dsPIC33FJ06GS101/X02 and dsPIC33FJ16GSX02/X04

dsPIC33FJ06GS101/X02 and dsPIC33FJ16GSX02/X04 Family Silicon Errata and Data Sheet Clarification

The dsPIC33FJ06GS101/X02 and dsPIC33FJ16GSX02/X04 family devices that you have received conform functionally to the current Device Data Sheet (DS70000318G), except for the anomalies described in this document.

FIGURE 1: TIMING DIAGRAMS FOR CENTER-ALIGNED AND EDGE-ALIGNED MODES

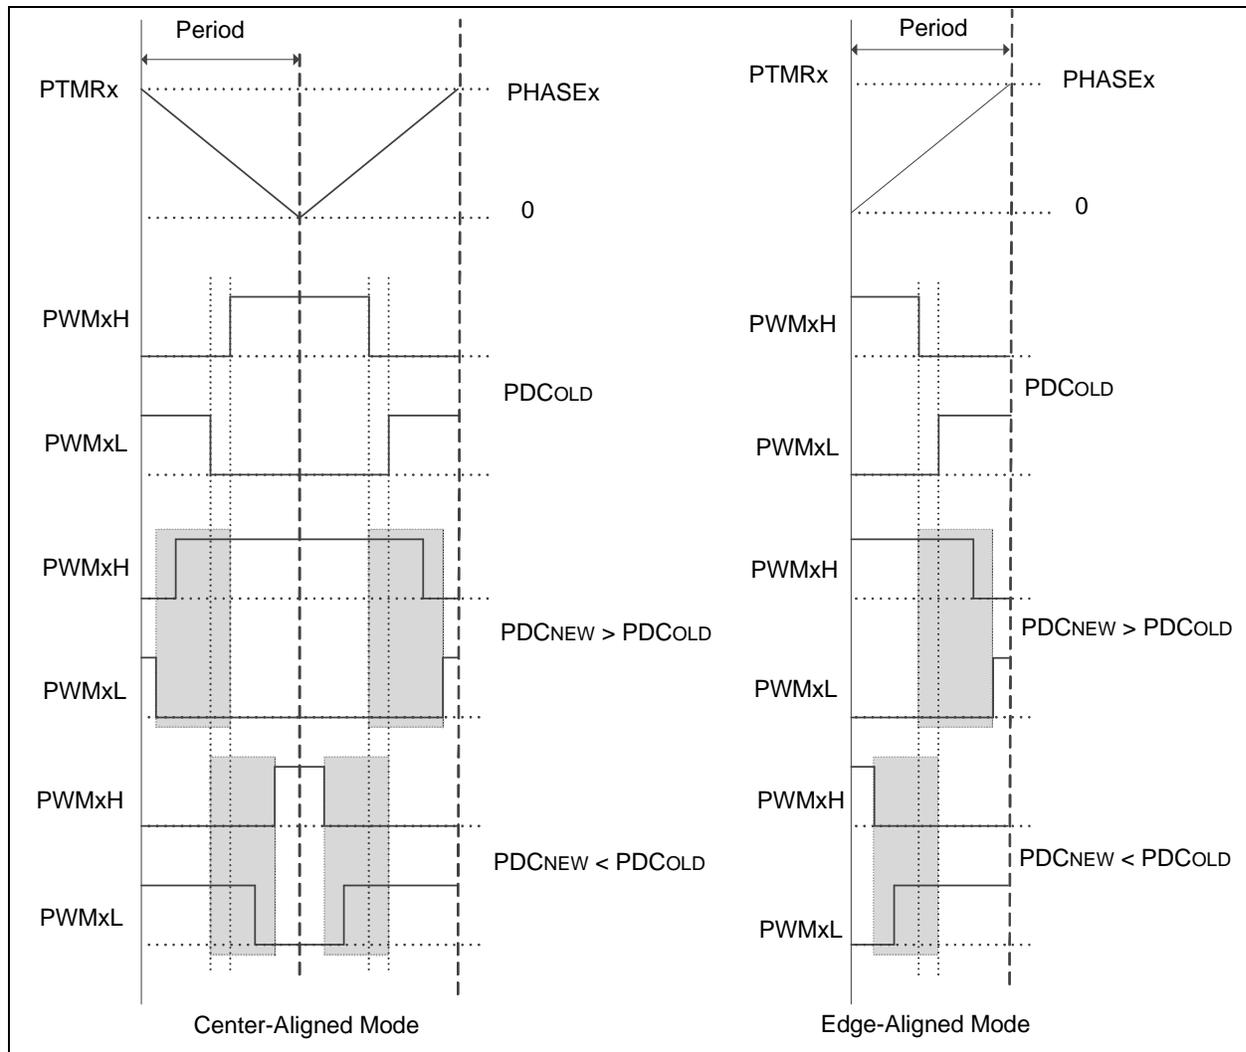
The PWMx current-limit operation allows the PWMx module to set/reset the output signals when a specific current limit is detected with a minimum latency delay. When operating the PWMx module in Complementary mode (PMOD = 0), positive dead time, and with Current-Limit Interrupt Enable (CLIEN = 1), a less than 8 ns pulse glitch on the complementary output may be present right after the current limit is detected. This glitch, if present, will occur prior to the implementation of the dead time.

In [Figure 1](#) (following page), if the duty cycle write occurred in the shaded box, then PWMxH and PWMxL will make an immediate transition without dead time.

FIGURE 2: ISSUE EXAMPLE FOR REDUNDANT OUTPUT MODE

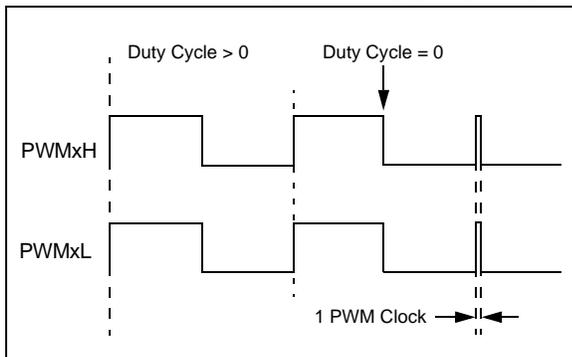
In Redundant Output mode (IOCONx<11:10> = 01) and Push-Pull Output mode (IOCONx<11:10> = 10), with the Immediate Update disabled (PWMCONx<0> = 0), when the Duty Cycle register is updated from a non-zero value to zero, a glitch pulse of a width equal to 1 PWM clock will appear at the next PWM period boundary, as shown in Figure 2 (for the Redundant Output mode). The Duty Cycle register refers to the PDCx register if PWMCONx<8> = 0 or the MDC register if PWMCONx<8> = 1.
